## Product Change Notification

**1. ECR #:** 219028  
**Notification #:** 661

- PCUO - PCUO ASSEMBLY
- ECUO - OPTICAL FIREFLY ASSEMBLY
- OTP - OTP

Product with No Underfill

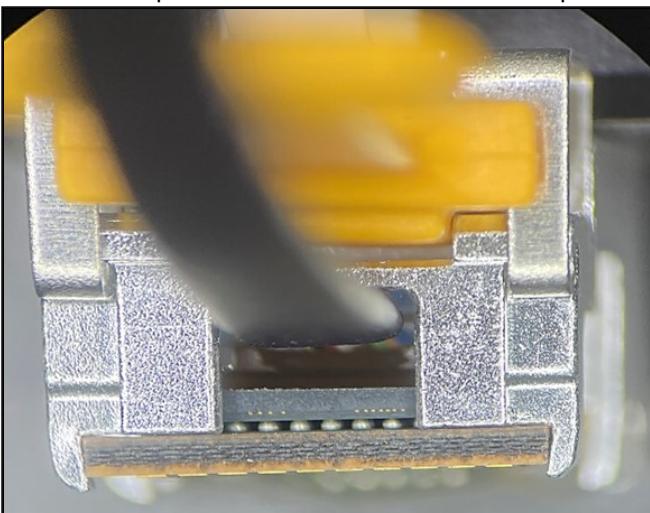
Implement the use of reballled and underfilled microcontrollers. This is a rolling change and mixed shipments are expected.

Underfill encapsulation is visible on backside of optical engine underneath microchip.

Product with Underfill

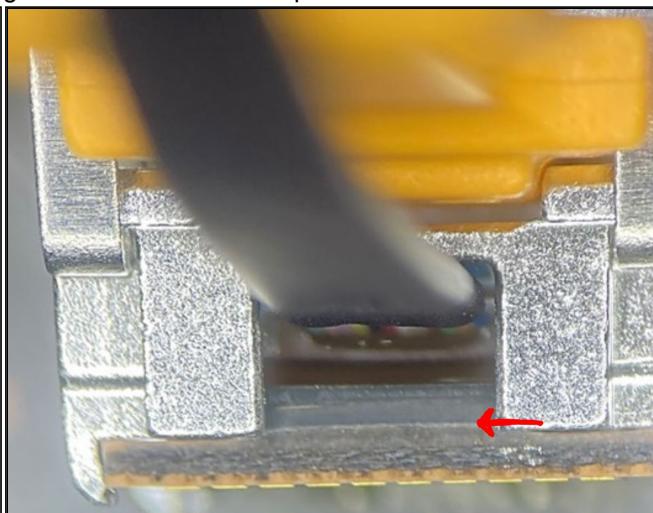
- Form - Underfill epoxy present under the microcontroller
